— PLANNING AND ZONING COMMISSION —

May 12, 2020
6:00 P.M.
City Council Chambers

Agenda Item: 7.C. Consider recommendation on request for approval of a Preliminary Plat for Ashton Park Plat 7.

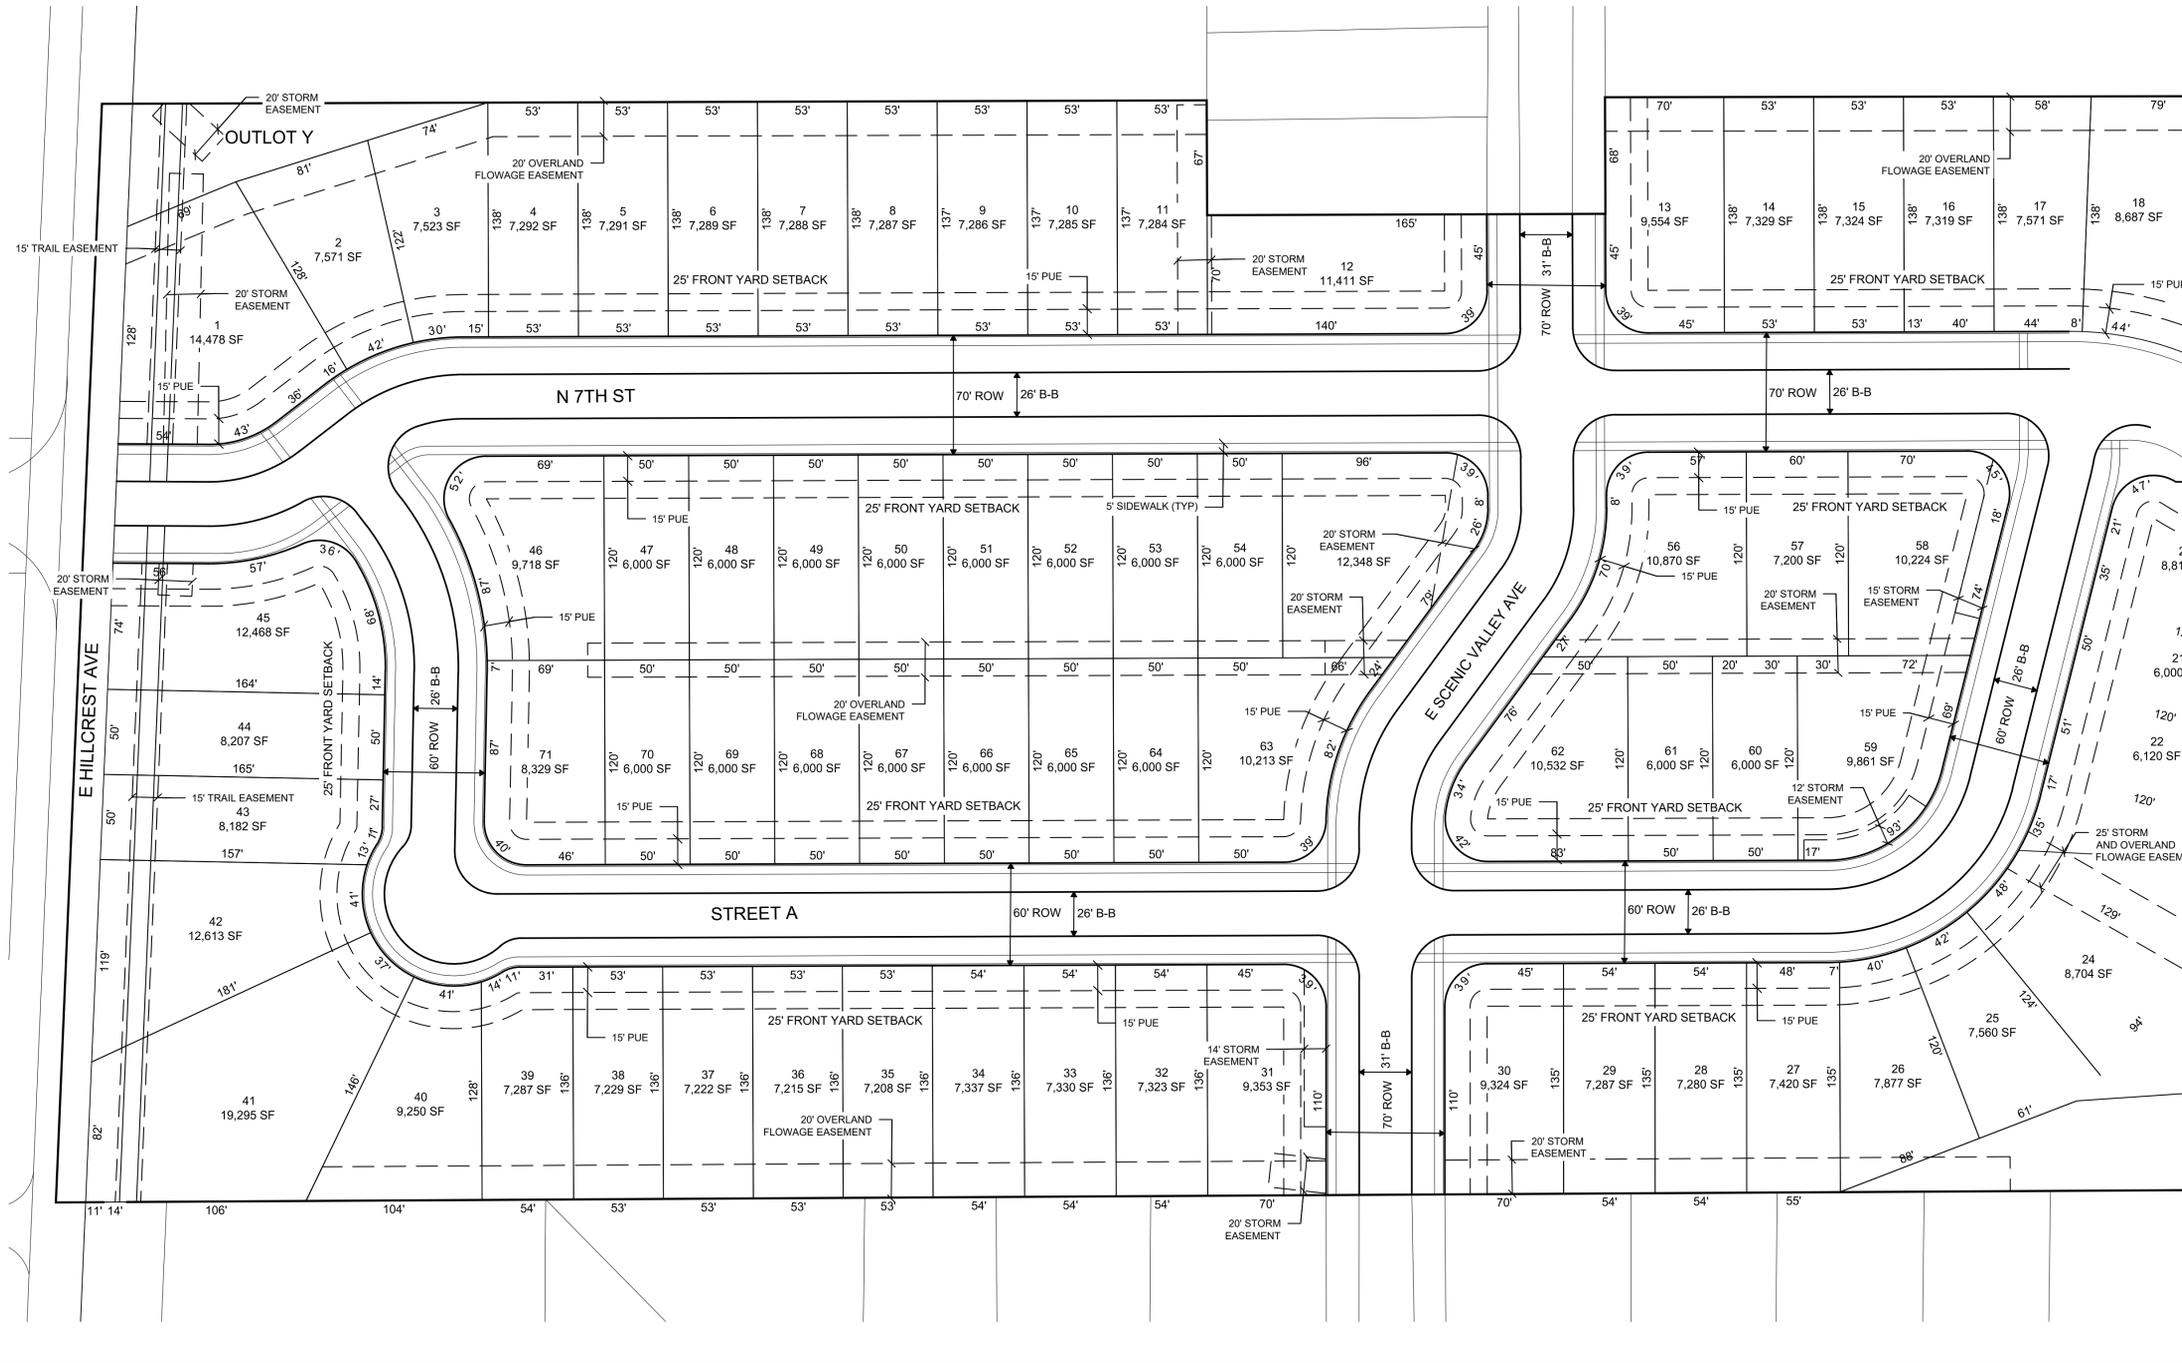
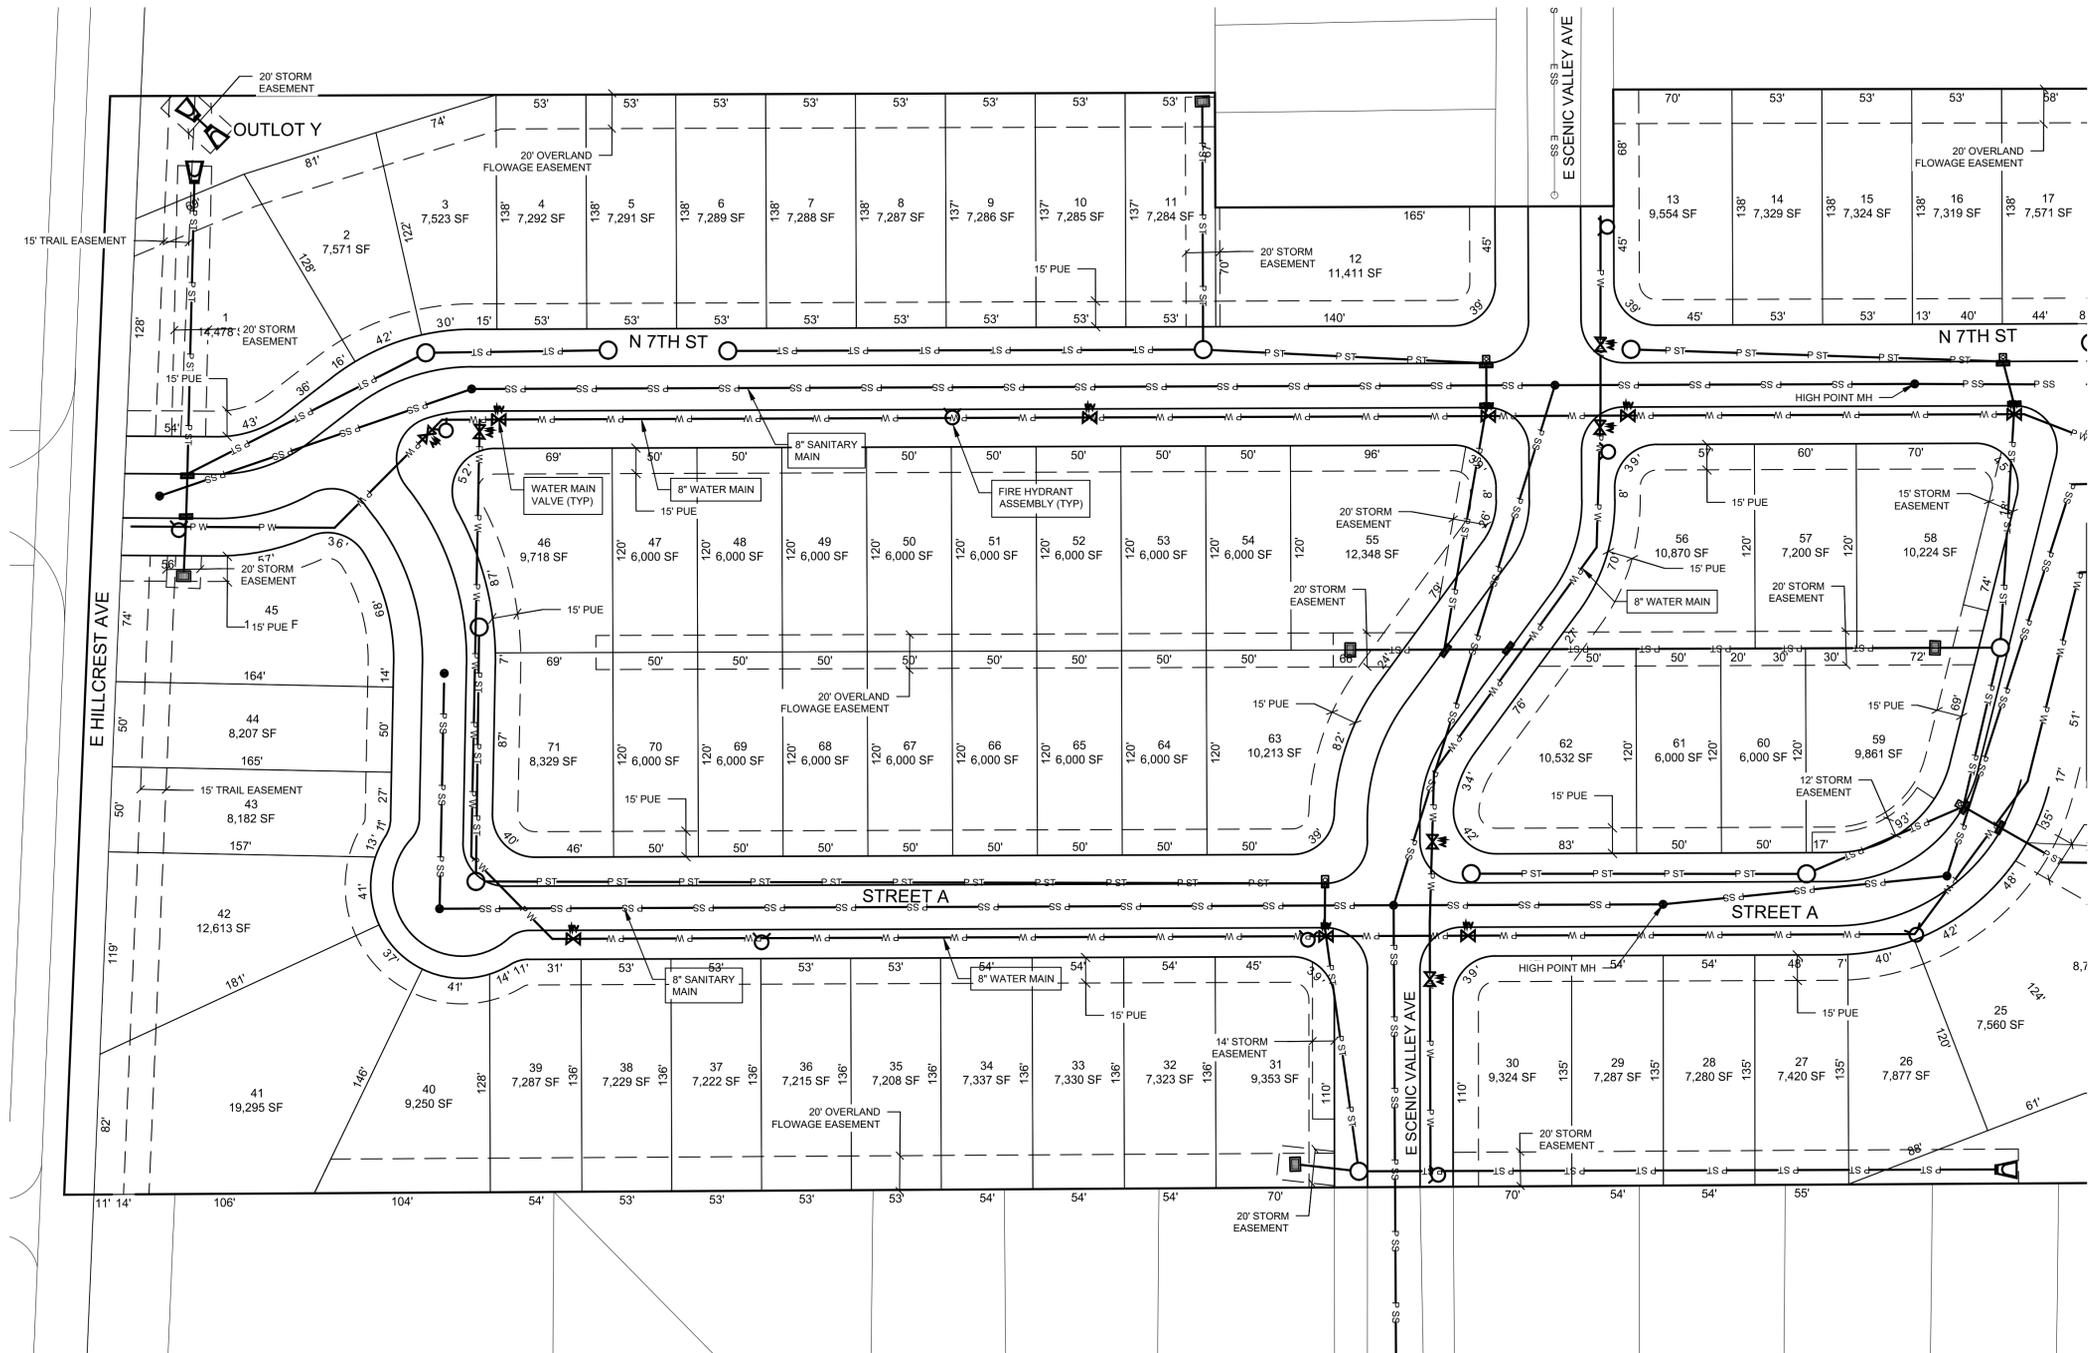
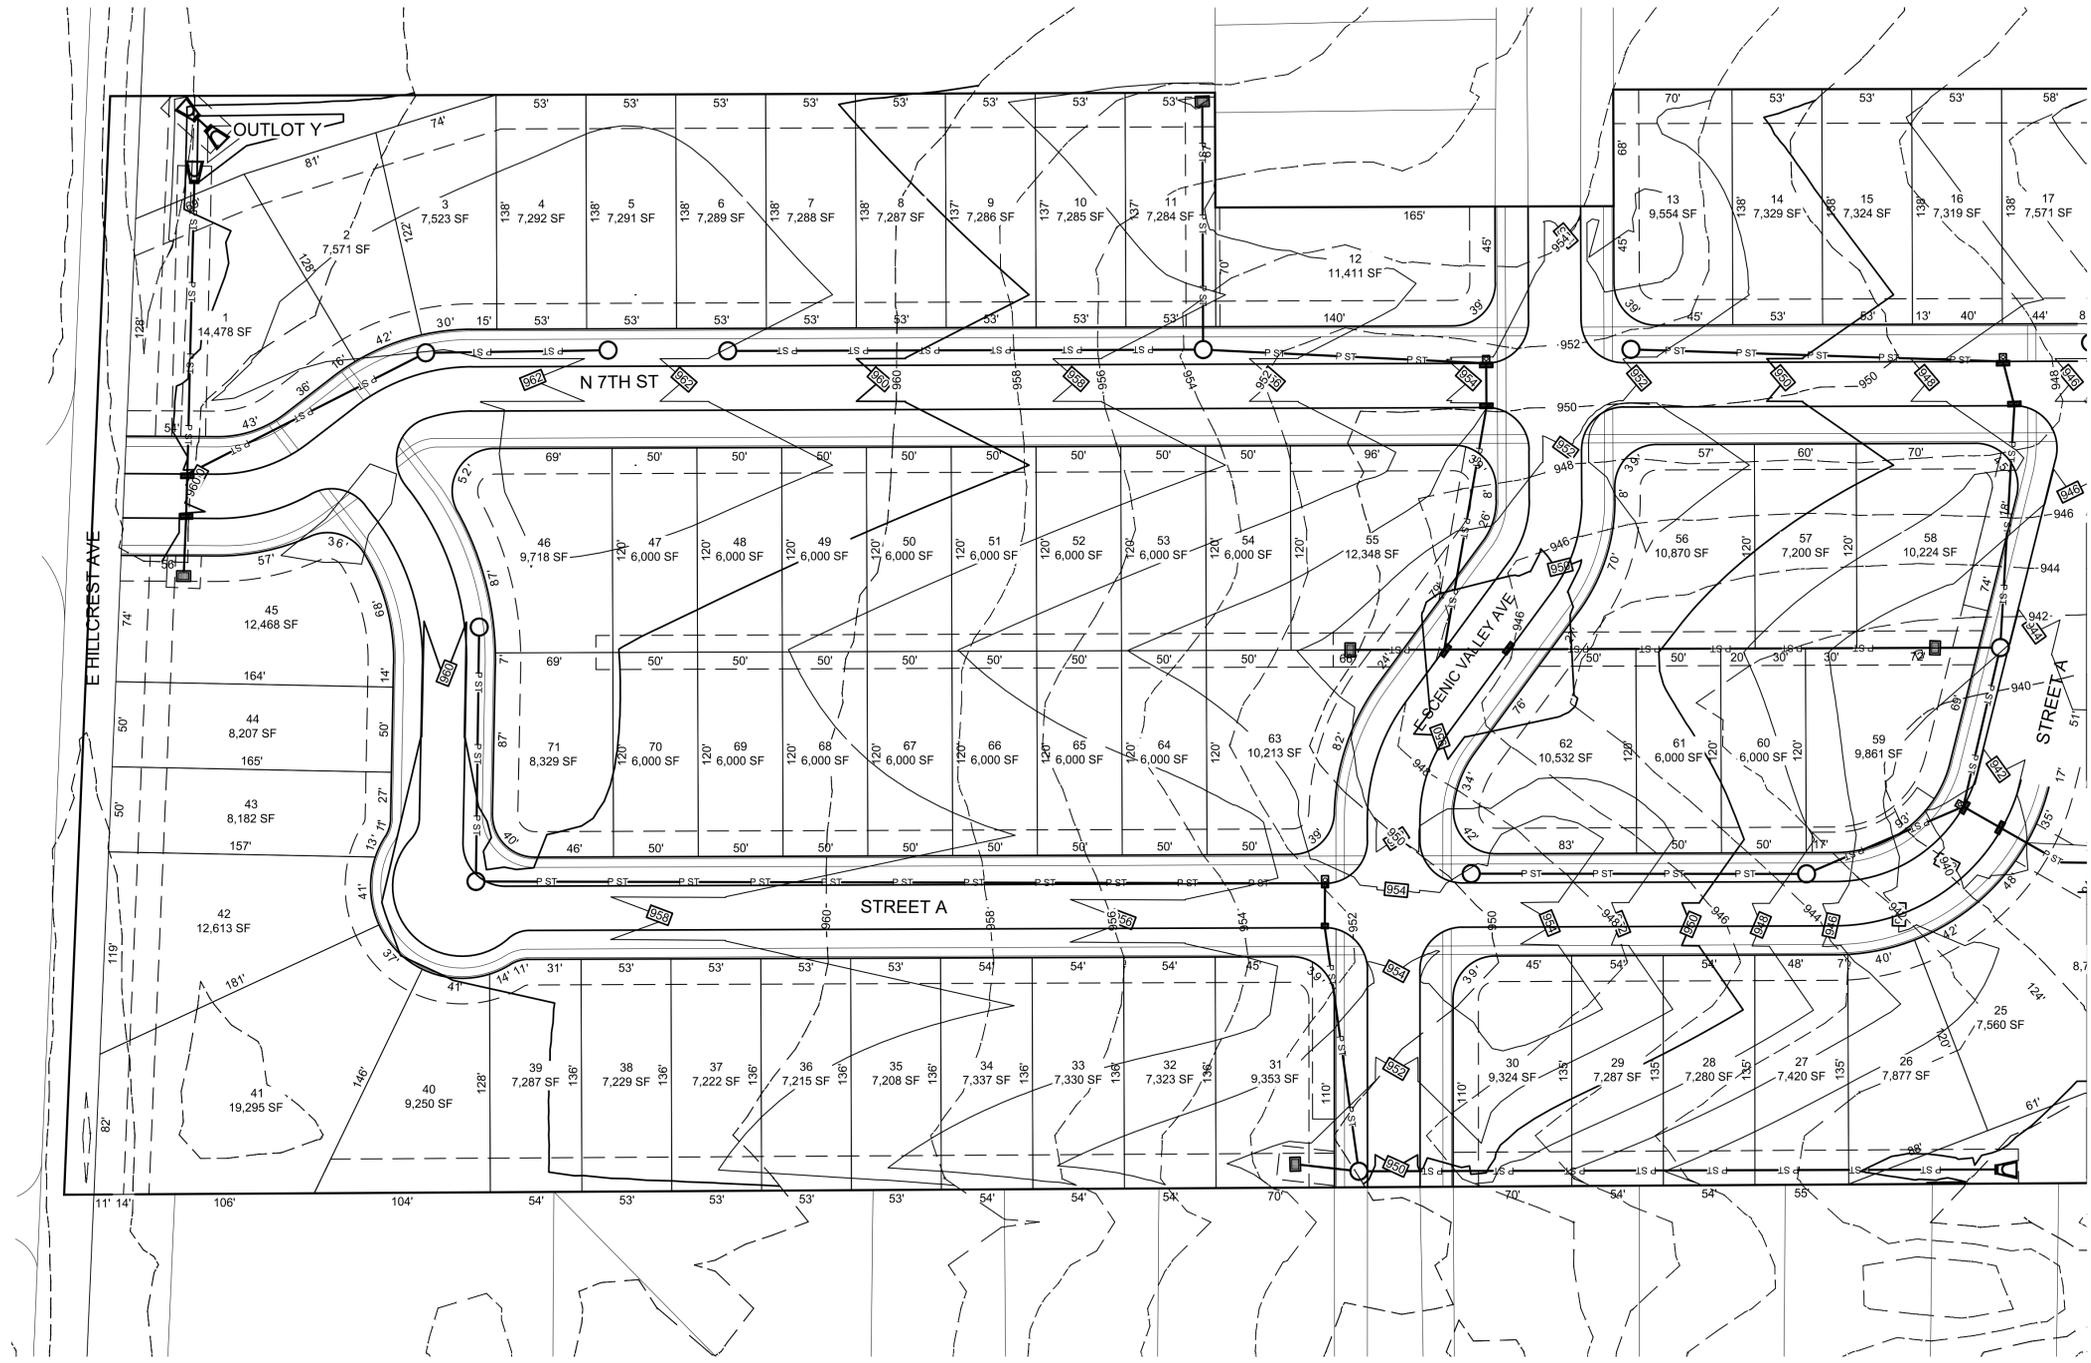
1. Sheet 3:
 - a. Both internal and along the boundaries of the development are areas where surface drainage is conveyed to a surface area intakes. These mainly exist along the rear lot line. We suggest adding a drainage easement to ensure that the rear lot line area are constructed and protected for the use of surface drainage. The drainage easement should be included wherever overland flow is conveyed, so the rear yard of lots 1-11, 13-18, 31-40, 47-56, and 65-73 areas to be reviewed.
Added overland flowage easements.

- b. There are storm sewer easements shown on Sheet 4 and should be included on the Sheet 3, Lot Layout.
Added storm sewer easements to the lot layout sheet.

2. Sheet 4
 - a. The preliminary plat is not intended to be used to review sizing of storm sewer facilities. We will review this in more detail during the public improvement submittal. It should be noted that material and size requirement should meet the City of Indianola standards
Removed storm sewer sizing labels.

- b. The storm sewer and associated easement along the north line of lot 19 should be analyzed to determine if it can parallel the lot line. This will be easier to dedicate during the final plat submittal. Other locations that have a skewed easement should be reviewed.
Revised easements. Will look into more detail for construction plans

3. Sheet 5:
 - a. It is noted base on the contour the area between lots 23 and 24 is at a low point in the storm sewer system. The design storm will need to be analyzed to convey overland along the lot line and into the detention area. This may require additional easement width.
Adjusted easement to be 25' storm sewer and overland flowage easement. Overflow grading to be detailed with construction plans.
